NL-17-144

Subject: **Indian Point Nuclear Generating Unit No. 2**  
**Proposed License Amendment Regarding Spent Fuel Storage**  
Docket No. 50-247  
License No. DPR-26

Pursuant to 10 CFR 50.90, Entergy Nuclear Operations, Inc. (Entergy) hereby requests an amendment to the Technical Specifications (TS) for Indian Point Unit No. 2 (IP2). This request proposes to:

- Revise TS LCO 3.7.13 Spent Fuel Pit Storage
- Revise TS Design Features 4.3 Fuel Storage

Figure 3.7.13-1  
IP2 Fuel Assembly Limiting Burnup and Cooling Time versus Initial Enrichment:  
Acceptable for Storage in Any Location in  
Region 2-1, Region 2-2, Region 1-2 or Region 1-1

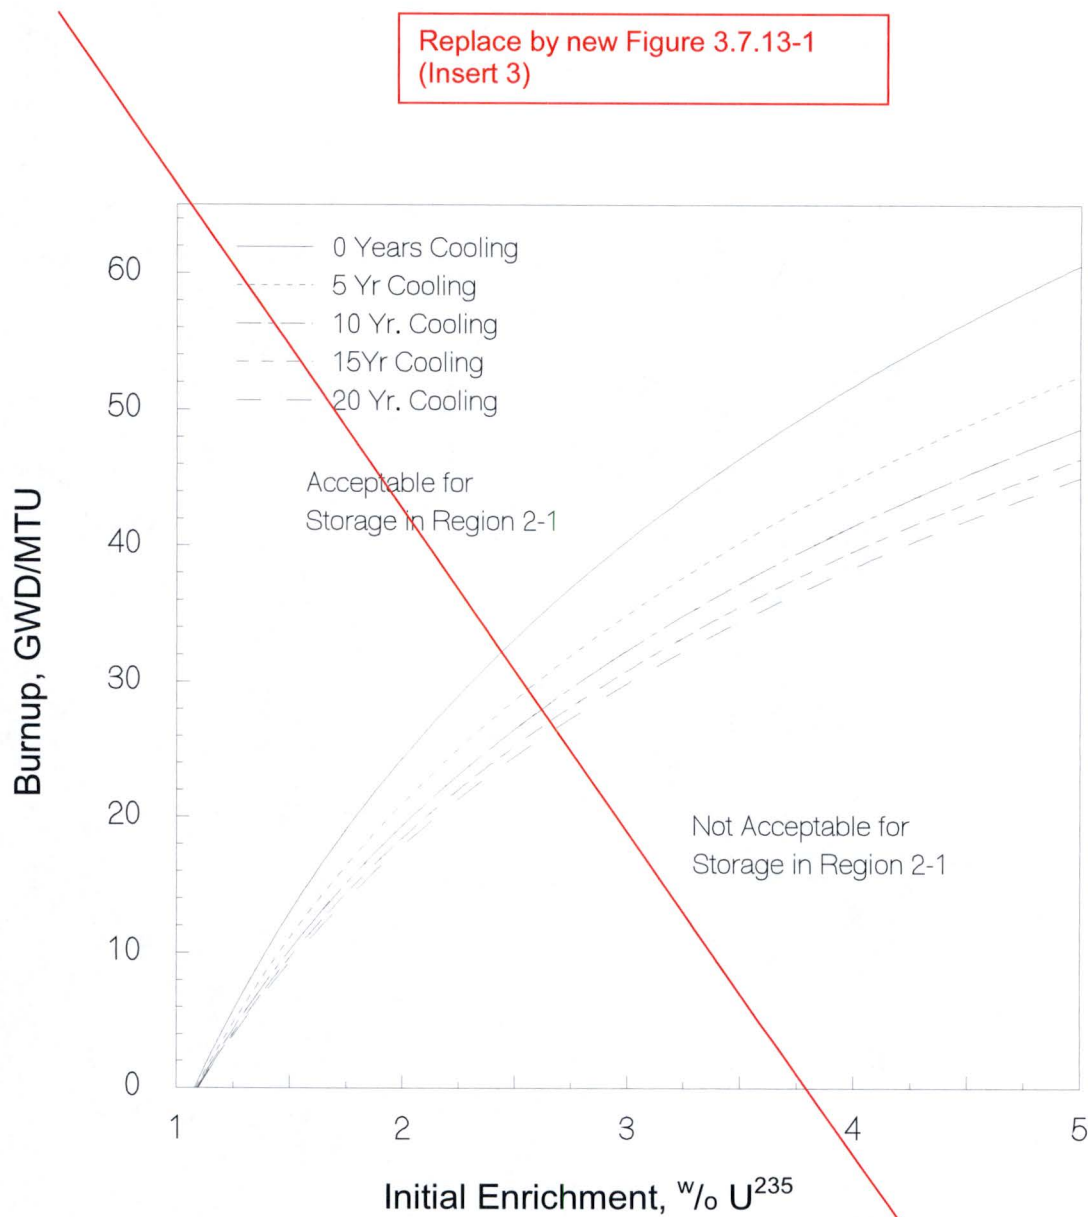
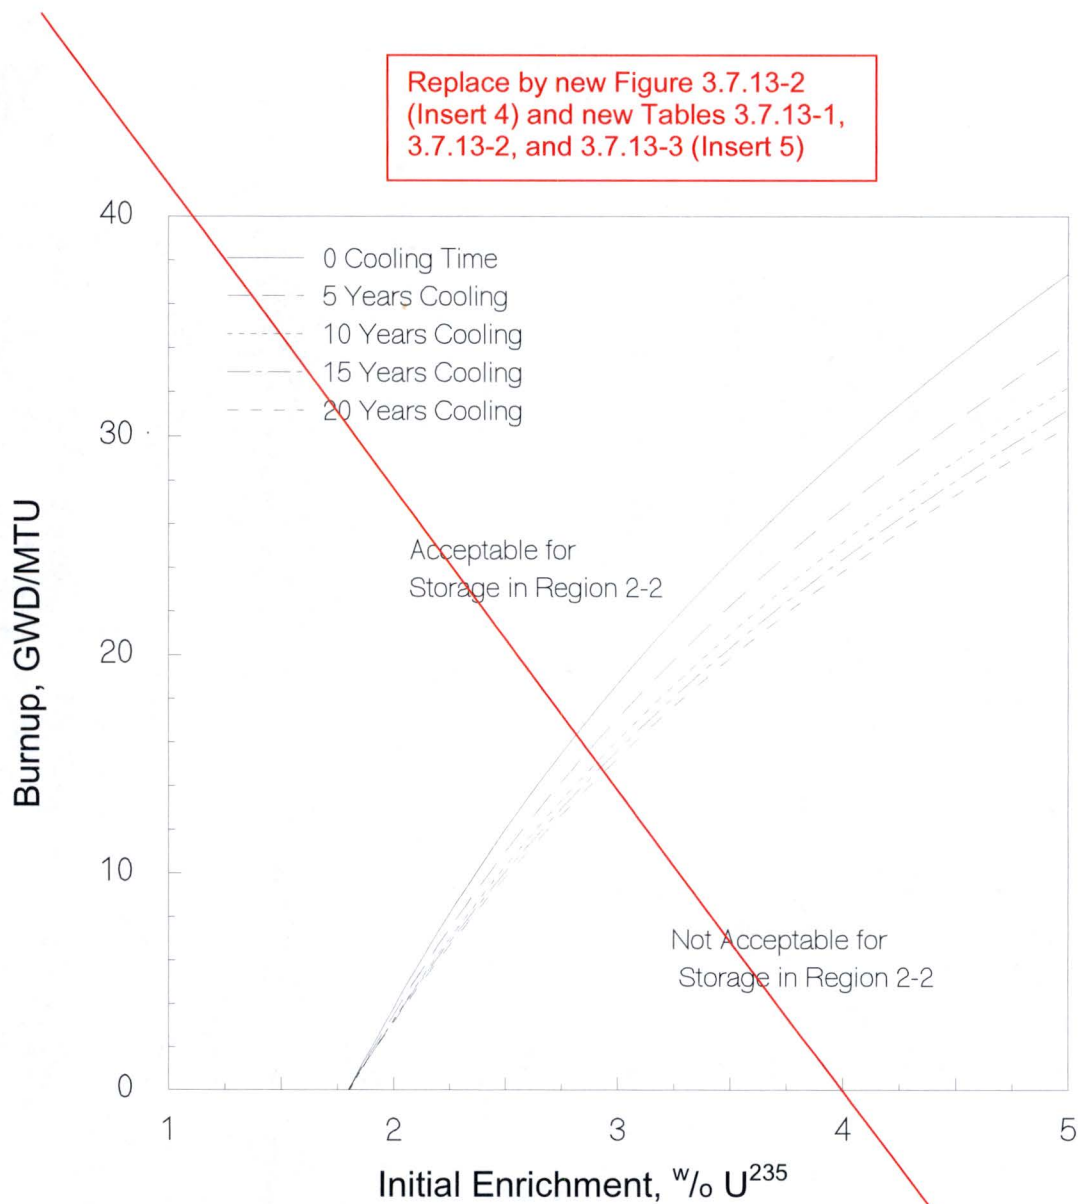
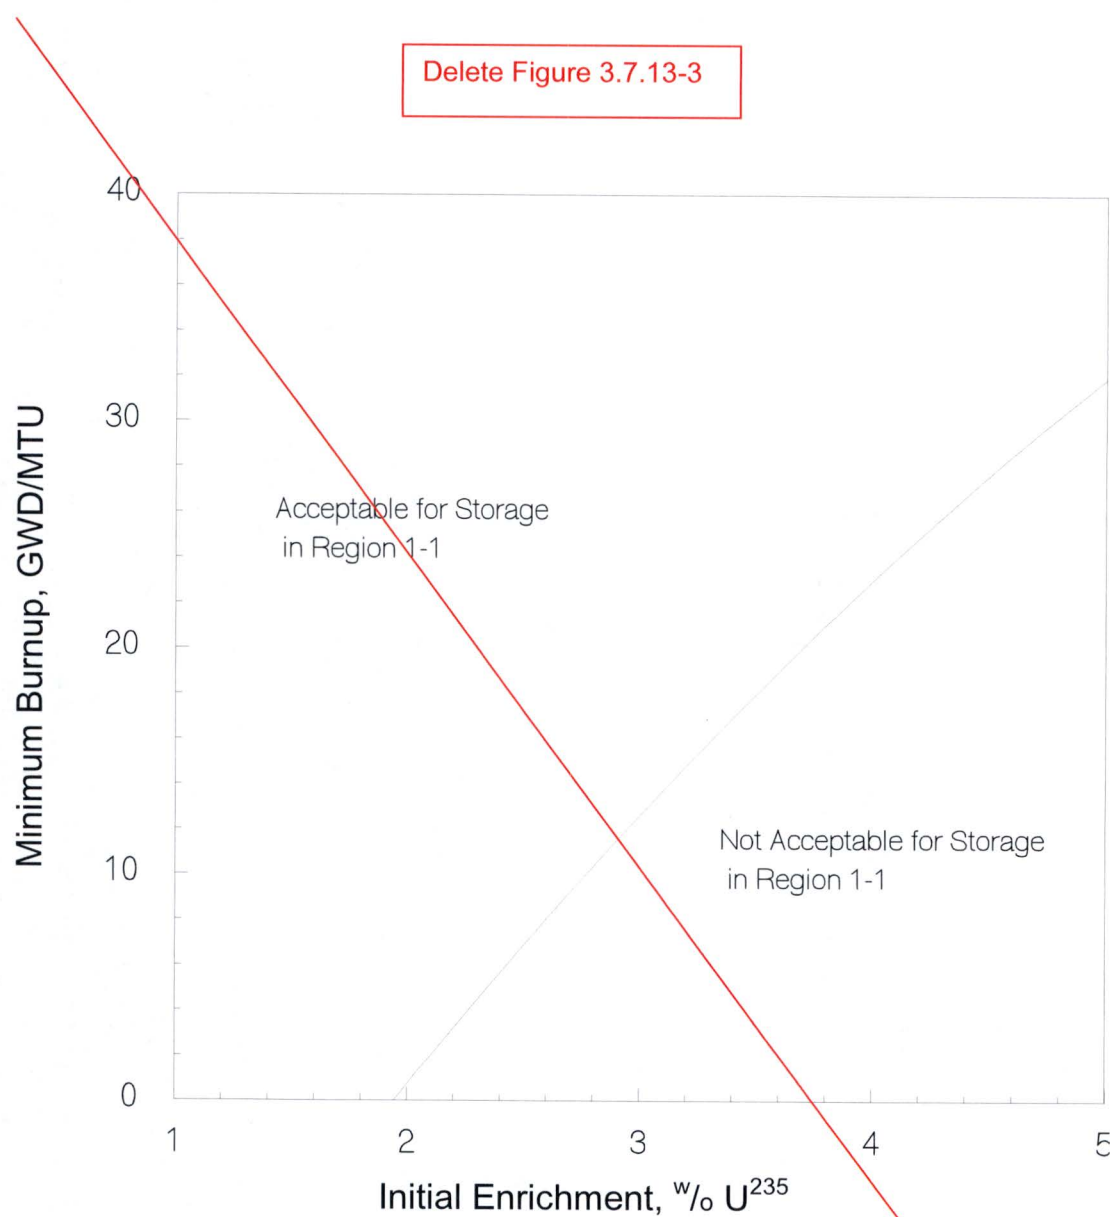
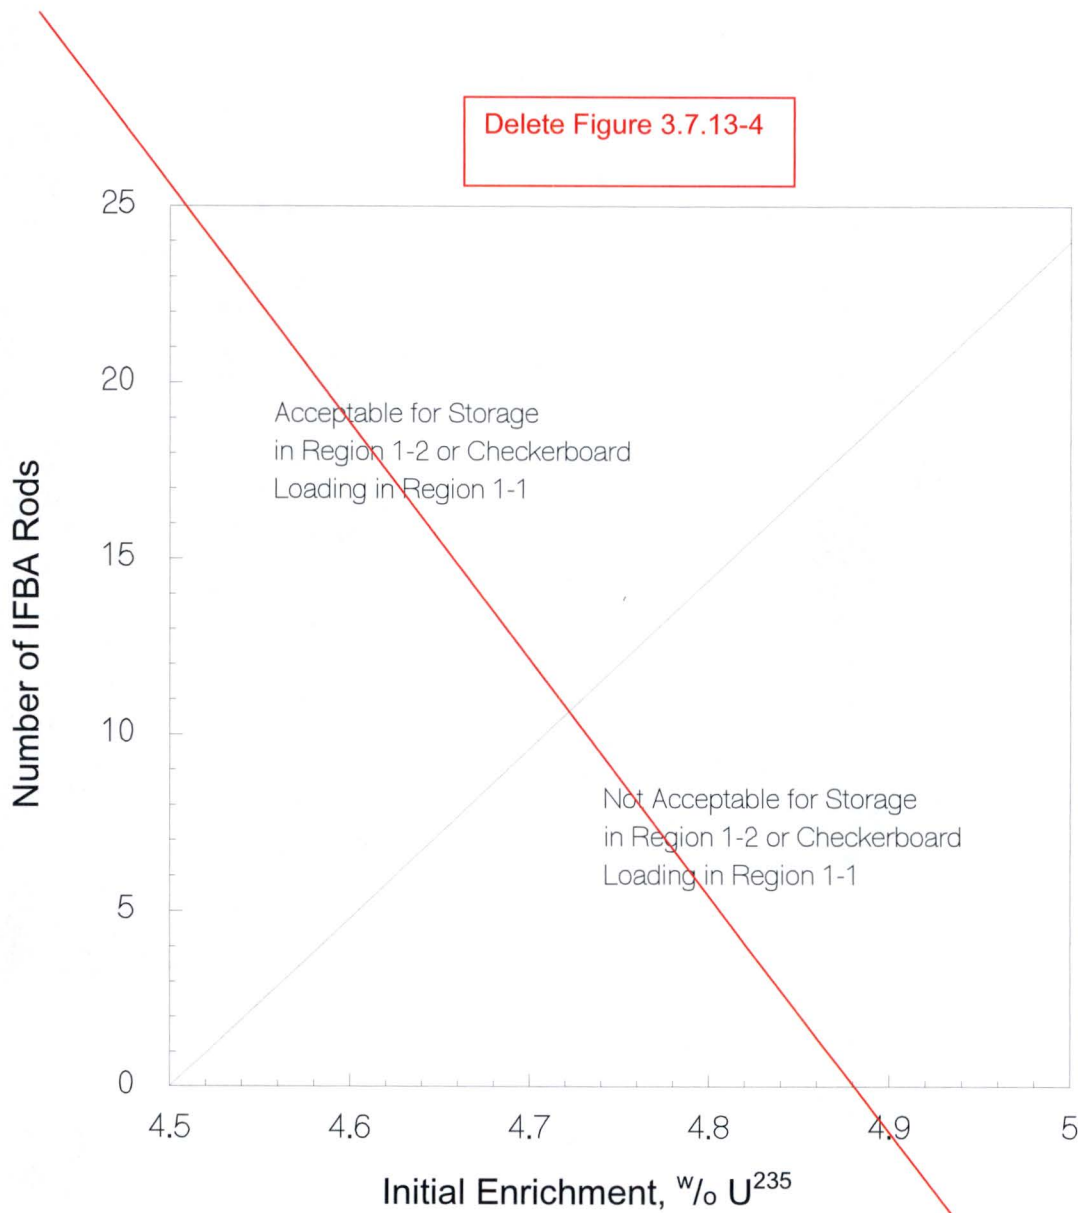
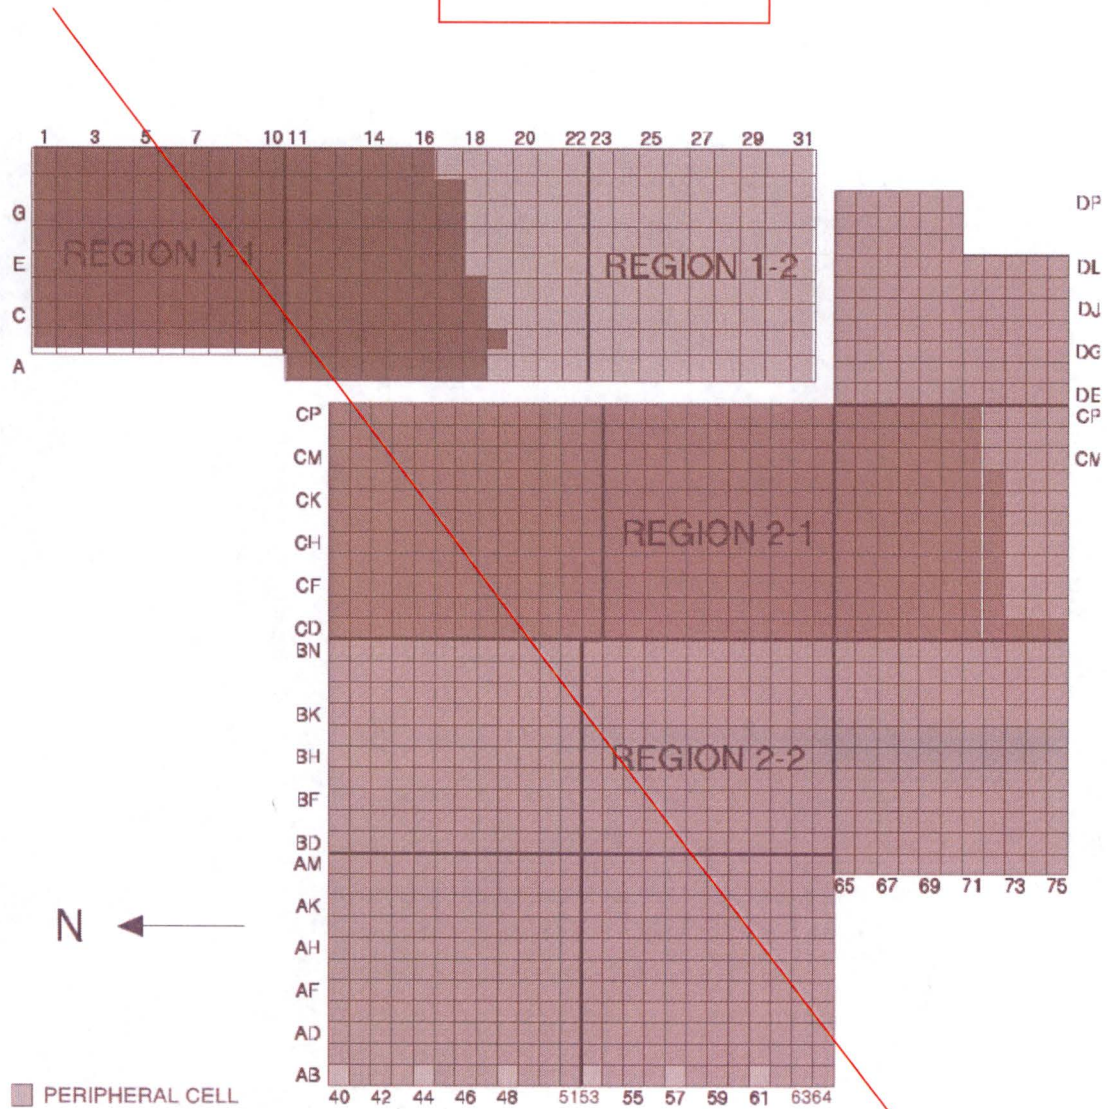
Figures 3.7.13-1 through Figure 3.7.13-5

Delete Figure 3.7.13-5

Figures 3.7.13-1 through Figure 3.7.13-5

Figure 3.7.13-1 (page 1 of 2)  
 Allowable Spent Fuel Pit Storage Locations for Category 1 through Category 5 Fuel Assemblies  
 in Regions 1 and 2

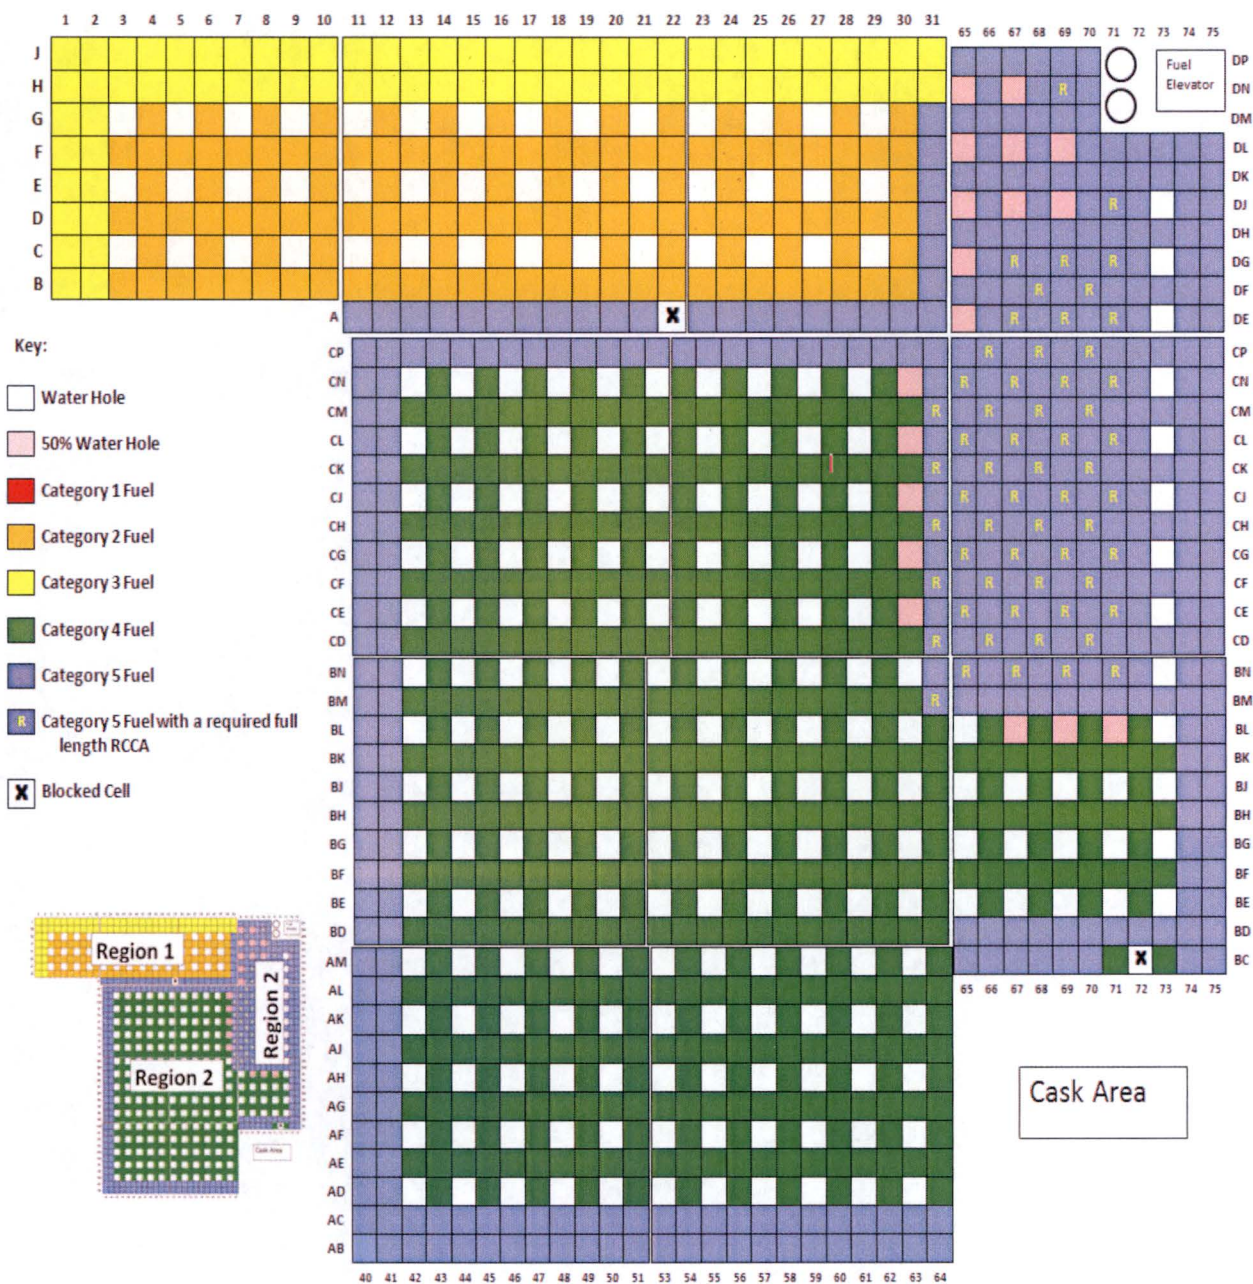
Section 10 of the CSA addresses normal loading configurations. Figure 10.1 of the CSA and TS Figure 3.7.13-1 show the base case normal configuration. This is the most limiting reactivity arrangement and, as such, is the configuration used in the accident analyses. As shown in the notes to TS Figure 3.7.13-1 fuel assemblies of any higher numbered Category can be stored in any cell location that allows for a lower numbered Category. For example, a Category 5 fuel assembly can be stored in Category 1, 2, 3, 4, and 5 cells. Any cell may be empty.

Figure 10.1 of the CSA and TS Figure 3.7.13-1 show SFP cell locations where RCCAs are credited. These RCCAs that are required in the fuel layout may not be credited to raise the category of that fuel assembly (for example, a Category 2 assembly with an inserted RCCA may not be placed in a location that requires an RCCA).

Figure 10.1 of the CSA and TS Figure 3.7.13-1 show SFP cell locations where Water Holes and 50% Water Holes are credited. Water Holes and 50% Water Holes are defined in the notes to TS Figure 3.7.13-1.

Figure 10.1 of the CSA and TS Figure 3.7.13-1 show two blocked cells. One of these cells is at the Region 1 and 2 interface and is not credited. The other is located at the edge of the pool above the cask loading area. This cell blocker is

IP2 and IP3 fuel assembly storage locations within the Spent Fuel Pit shall be restricted to locations allowed by Figure 3.7.13-1 and its associated notes.

Regarding Category 5 fuel assemblies that are required by Figure 3.7.13-1 to contain a full length RCCA - The RCCA must not be placed in or removed while the assembly is in an RCCA required location unless all 8 adjacent cells are empty.

Figure 3.7.13-2  
Examples of Allowable Spent Fuel Pit Storage Locations for Category 1 Fuel Assemblies in  
Region 1

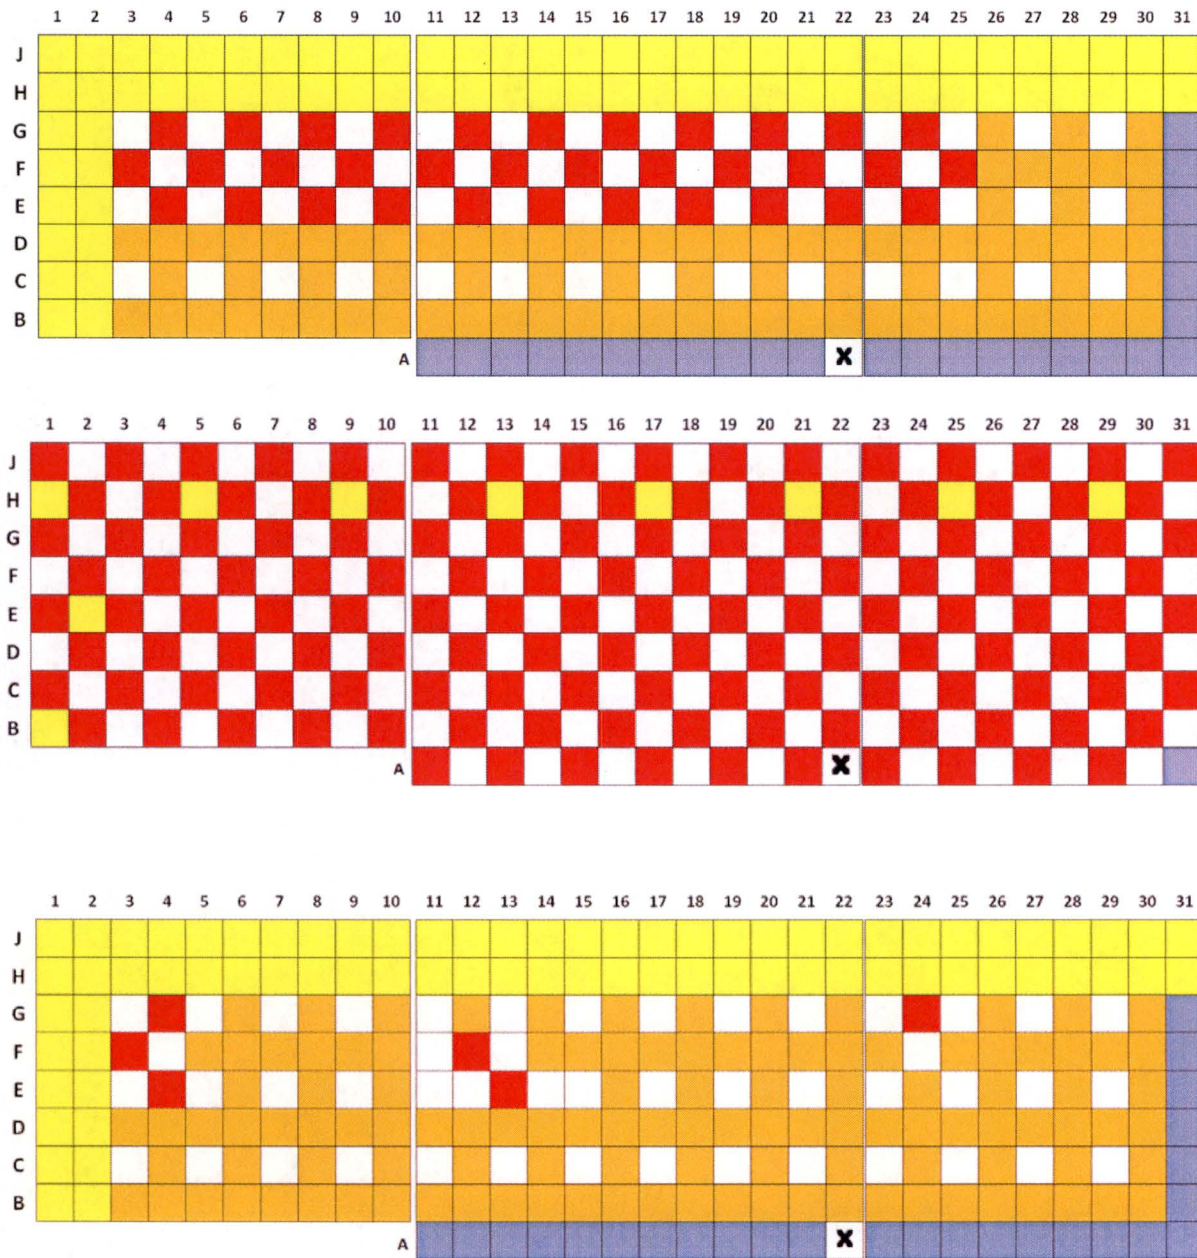
Section 10.3 of the CSA and the notes to TS Figure 3.7.13-1 allow for the formation of areas of Category 1 fuel in both Regions 1 and 2. Region 1 examples are provided in TS Figure 3.7.13-2.

10. A Blocked Cell has the same requirements as a Water Hole.
11. A checkerboard area consists of every other cell being a Water Hole.
12. An area of Category 1 fuel assemblies may be formed in Region 1. The Category 1 area must be formed by replacing the Region 1 arrangement shown in this figure with an area of Category 1 fuel assemblies in accordance with the following criteria (see examples in Figure 3.7.13-2):
